**BEFORE THE HEARINGS PANEL
FOR THE QUEENSTOWN LAKES PROPOSED DISTRICT PLAN**

IN THE MATTER of Stage 3b of the
Proposed District Plan

**SECOND REBUTTAL EVIDENCE OF EMILY SUZANNE GRACE
ON BEHALF OF QUEENSTOWN LAKES DISTRICT COUNCIL**

**PLANNING: CHAPTER 46 RURAL VISITOR ZONE – TEXT, VARIATION AND
MAPPING**

Figure 1: Eastern zone boundary to be the eastern extent of the lower sensitivity area identified by Mr Milne (note, north is to the left of the diagram)

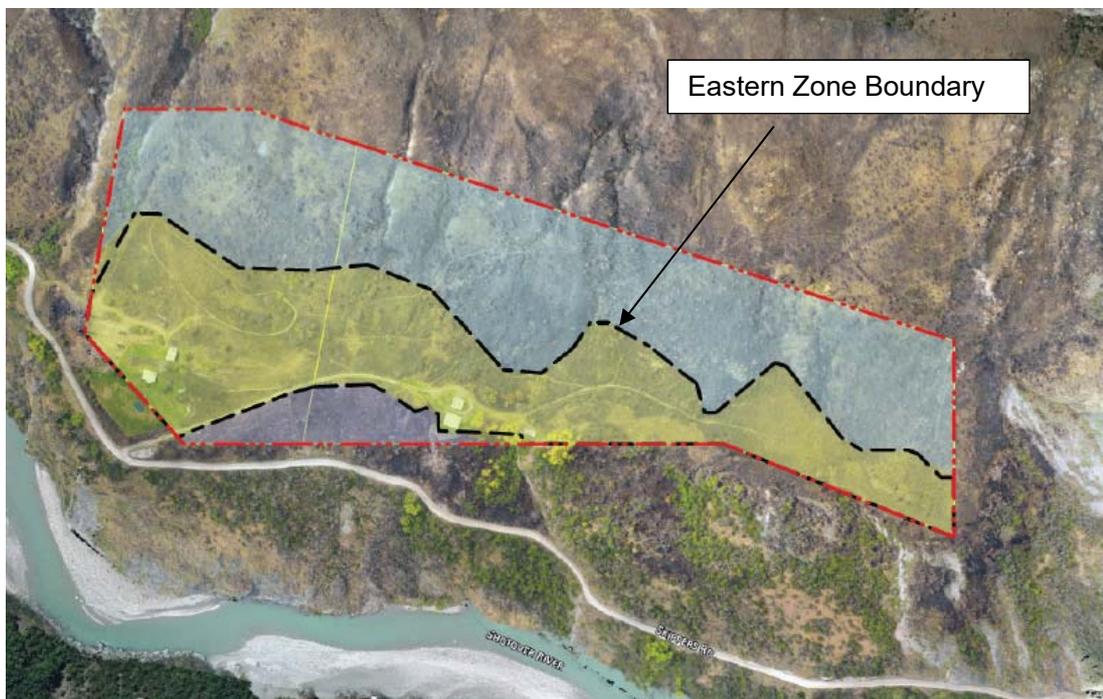
3.7 As outlined above, Mr Jones has a different opinion to Mr Milne on the sensitivity rating for some parts of the Skippers RVZ site. There is agreement between both landscape architects on the area of low landscape sensitivity. The intention of the RVZ, expressed in Policy 46.2.1.a is for areas of RVZ to be largely comprised of areas of lower landscape sensitivity. Given this policy direction, and Mr Jones' advice about the areas of higher landscape sensitivity, I consider the policy direction of the RVZ would be better implemented by excluding the area identified by Mr Milne as moderate-high sensitivity from the zone. My recommendation, should the site be re-zoned, is that the eastern zone boundary be the eastern extent of the lower sensitivity area identified by Mr Milne, as indicated in **Figure 1** below.

3.11 In summary, I consider the outstanding landscape matters for re-zoning the site can be addressed by modifying the extent of the zone, as indicated in **Figure 1** above. I do not agree with the method proposed by Mr Farrell for incorporating the landscape sensitivity mapping and structure plan in the PDP. Should the site be re-zoned to RVZ (which I do not recommend for natural hazard reasons, discussed below), I recommend that the landscape sensitivity mapping in Mr Milne's evidence identifying the lower and high landscape sensitivity areas be included on the planning maps, as amended by **Figure 1** above. I consider this is all that is required as the notified RVZ provisions already relate directly to the landscape sensitivity areas, this is a far more efficient planning approach compared to complicating the RVZ chapter with an unnecessary structure plan. I consider that the RVZ provisions should apply as amended in Appendix 1 to this rebuttal statement.

Figure 2: alternative location of western boundary of Gibbston Valley Station RVZ, shown by red line.

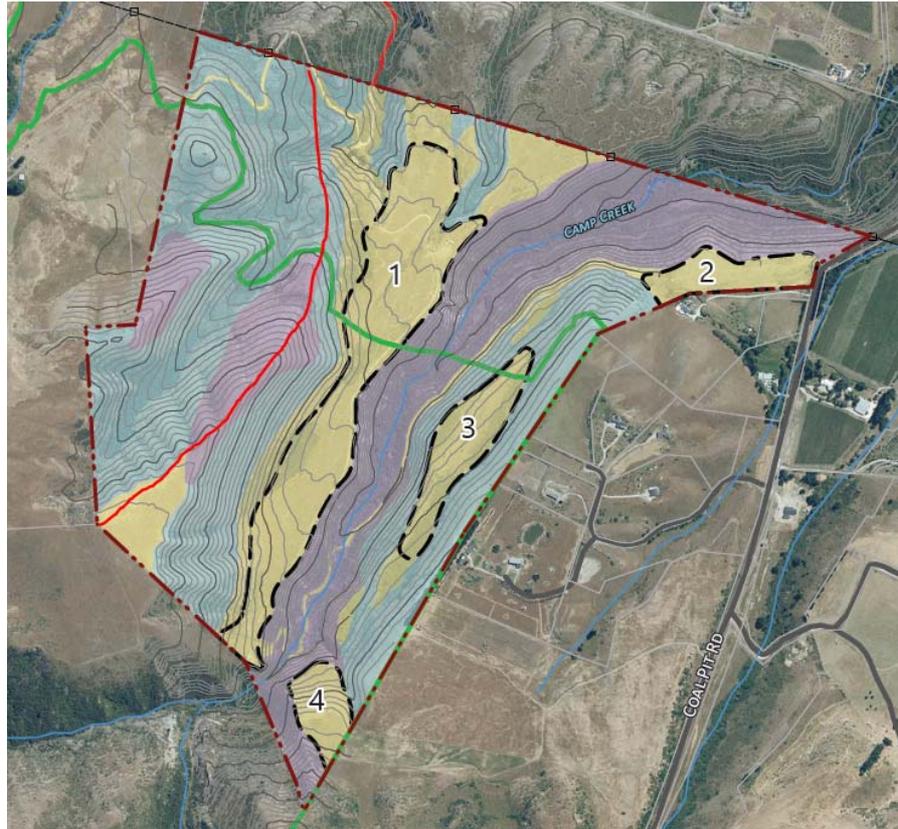
5.5 Mr Giddens proposes that the structure plan attached to Mr Milne's evidence be incorporated within the PDP. The reduced area covered by the structure plan and re-zoning request, as compared to the larger area requested in the submission, is discussed at paragraphs 26 and 27 of Mr Giddens' evidence. In my opinion, the size of the RVZ is still large, and the landscape sensitivity mapping suggests it is not made up largely of areas of lower landscape sensitivity. At paragraph 4.22 of my s42A I discuss my reasons for adding a new policy requiring new areas of RVZ to be largely within areas of lower landscape sensitivity. I also discuss changes to the Purpose statement in order to more clearly articulate the way landscape is managed in the RVZ. The first means of implementing landscape management is through the extent of the zone itself. I consider the policy direction would be better achieved if the western boundary of the proposed zone was moved eastward to align with the ridgeline to the immediate west of 'buildable area 1', along the line shown by the red line in **Figure 2** below. I consider excluding this western area from the re-zoning would better implement the policy direction for the RVZ.

- (a) Removal of the western part of the site from the zone, as shown on **Figure 2**;
- (b) Inclusion of the High and Moderate-High landscape sensitivity mapping in Mr Milne's evidence on the planning maps (rather than a structure plan), with an annotation such as 'height exception area' around Areas 1 and 3 (I note the same label can apply to both areas, as the height limit is the same in both areas);
- (c) Application of the RVZ provisions with one 'Gibbston Valley RVZ' specific rule, this being a height limit of 7m specific to the two areas identified in (b) above within the Gibbston Valley RVZ within Rule 46.5.1 (see **Appendix 1**);
- (d) Clarification that the 500m² total maximum ground floor area standard (46.5.2) applies to the Gibbston Valley RVZ (see **Appendix 1**).
